TOWN OF BARTONVILLE, TEXAS
ORDINANCE NO. 783-25

AN ORDINANCE OF THE TOWN COUNCIL OF THE TOWN OF BARTONVILLE, TEXAS AMENDING VARIOUS PROVISIONS OF CHAPTER 3, "BUILDING REGULATIONS," ARTICLE 3.02, "TECHNICAL AND CONSTRUCTION CODES AND STANDARDS," OF THE CODE OF ORDINANCES, TOWN OF BARTONVILLE, TEXAS, BY ADOPTING THE 2021 EDITIONS OF THE INTERNATIONAL BUILDING CODE, INTERNATIONAL RESIDENTIAL CODE, INTERNATIONAL MECHANICAL CODE, INTERNATIONAL PLUMBING CODE, INTERNATIONAL FIRE CODE, INTERNATIONAL SWIMMING POOL AND SPA CODE, INTERNATIONAL ENERGY CONSERVATION CODE, INTERNATIONAL FUEL GAS CODE, AND INTERNATIONAL EXISTING BUILDING CODE, AND THE 2020 EDITION OF THE NATIONAL ELECTRIC CODE; PROVIDING FOR THE MODIFICATION OF THE CODE TO INCORPORATE LOCAL AMENDMENTS; PROVIDING FOR THE RECORDING OF THE CODES AS PUBLIC RECORDS; PROVIDING THAT THIS ORDINANCE SHALL BE CUMULATIVE OF ALL ORDINANCES; PROVIDING A SAVINGS CLAUSE; PROVIDING A SEVERABILITY CLAUSE; PROVIDING FOR ENGROSSMENT AND ENROLLMENT; PROVIDING FOR A PENALTY FOR VIOLATIONS; PROVIDING FOR PUBLICATION IN THE OFFICIAL NEWSPAPER; AND PROVIDING AN EFFECTIVE DATE.

Figure 307.4

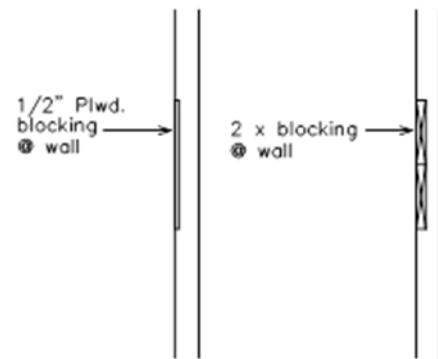
Section R307; amend by creating Section 307.4 and Figure 307.4 to read as follows:**R307.4 Blocking.** Blocking may be $\frac{1}{2}$ " plywood or equivalent or 2 x solid wood blocking flush with wall.

Figure R602.6.1; amended to appear and read as follows:

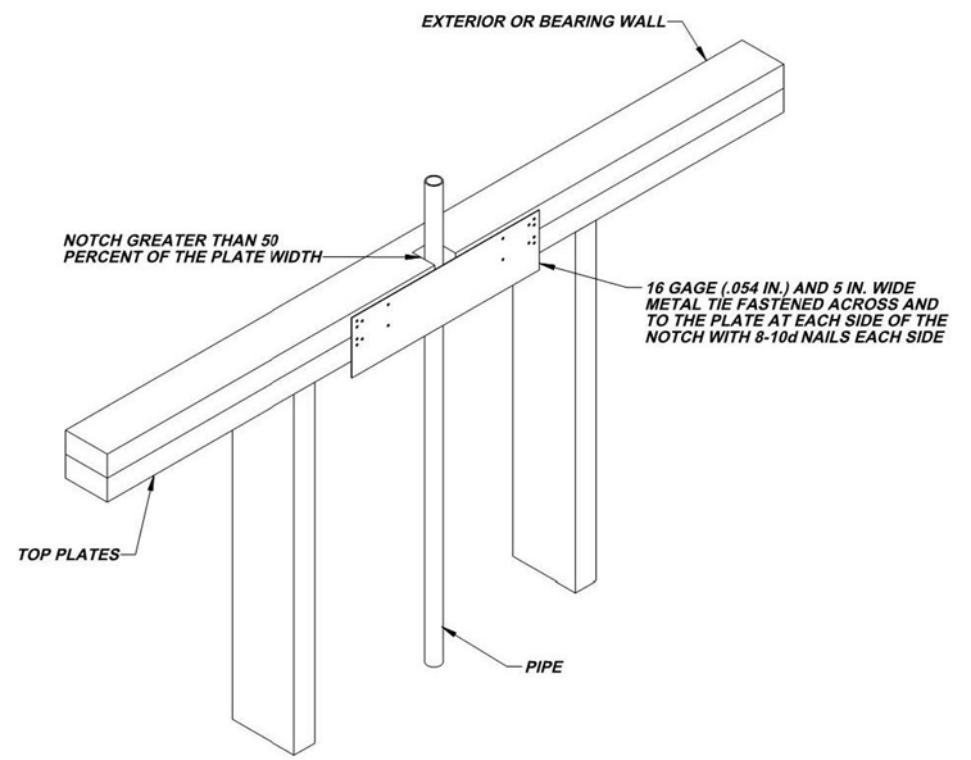
Plumbing in walls and top plates. Any plumbing in a stud wall and top plate 2" and larger shall be installed in a 2" x 6" stud wall and top/bottom plates.

Figure: 25 TAC § 265.186(e)(6)

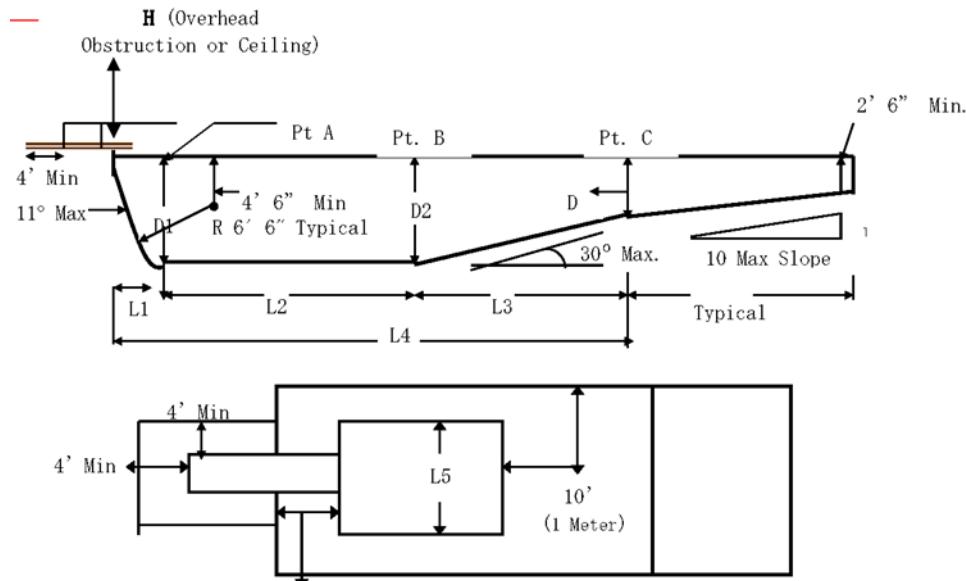
Section 402.12; amend to delete figure 402.12 and table 402.12, and to read as follows:

402.12 Water envelopes. The minimum diving water envelopes shall be in accordance with Texas Department of State Health Services, Administrative Code Title 25, Chapter 265, Section 186(e) and Figure: 25 TAC 256.186(e)(6).
